Product/Process Change Notice (PCN)

PCN #: PCN_WE-
StarTec_20161115_7427122x(S)_Capacity Increase

Product Affected: 74271221, 74271221S
74271222, 74271222S

Already established production line of plastic housing:

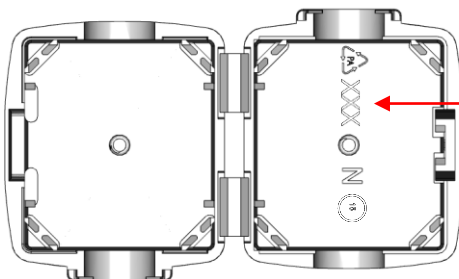
1. Neither the raw material nor the raw material supplier will be changed.
2. Neither electrical nor mechanical properties of the finished part will be changed.
3. The production lines can be identified by the three digits inside the plastic housing.

Digits: 128

Additional production line of plastic housing:

Digits: 375
